## ADDENDUM NO. 2

DATE: November 11, 2011

PROJECT: CAT DOWNTOWN INTERMODAL TRANSIT CENTER  
CHATHAM AREA TRANSIT AUTHORITY

This Addendum forms a part of the Contract Documents and modifies the original Drawings and Project Manual dated September 29, 2011.

TYPICAL BOLLARD ENTRANCE

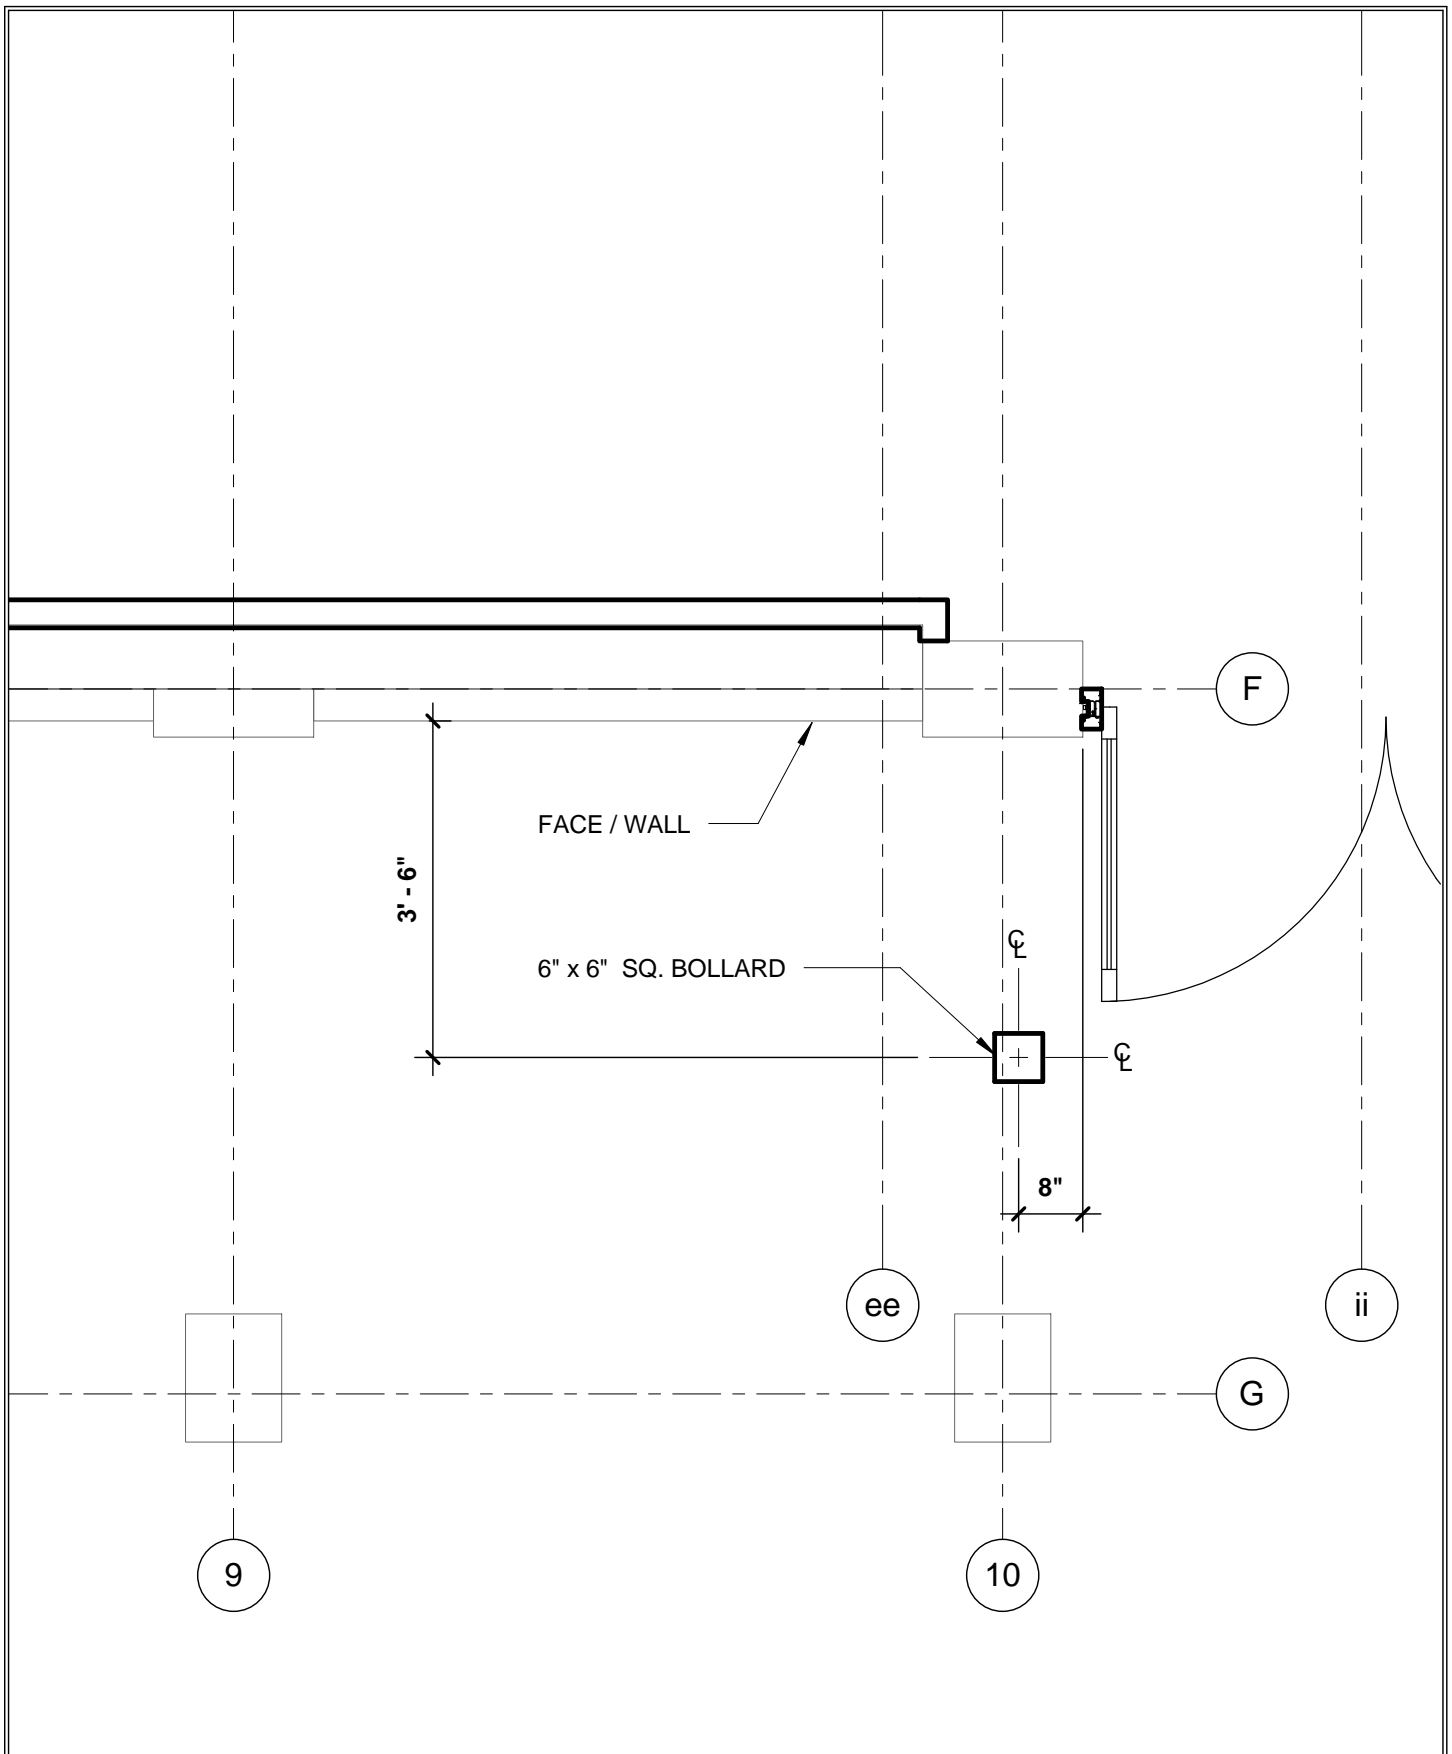
- K. Sheet A2.1, TERMINAL BUILDING - FLOOR PLAN: Furnish and install 6" x 6" x 42" high stainless steel bollard for door actuators in accordance with Section 08 71 00, DOOR HARDWARE, at Doors 101C and 101E. Locate bollards at exterior face of wall, located 42" off face of wall. Refer to attached Sketch A2.1.R!, TYPICAL BOLLARD ENTRANCE, for typical location.

1. At Doors 101C and 101E (refer to Sheet A2.1, TERMINAL BUILDING FLOOR PLAN, for locations), revise location of j-box for actuators from exterior face of wall to bollard located 42" off face of exterior wall. Refer to attached Sketch A2.1.R1 for typical location.
2. At south face of south partition at Security 102, height of power outlet for Clock shall be 10'-2" as indicated on Elevation MY, Sheet DP5.2, DEMOUNTABLE PARTITIONS ELEVATIONS.
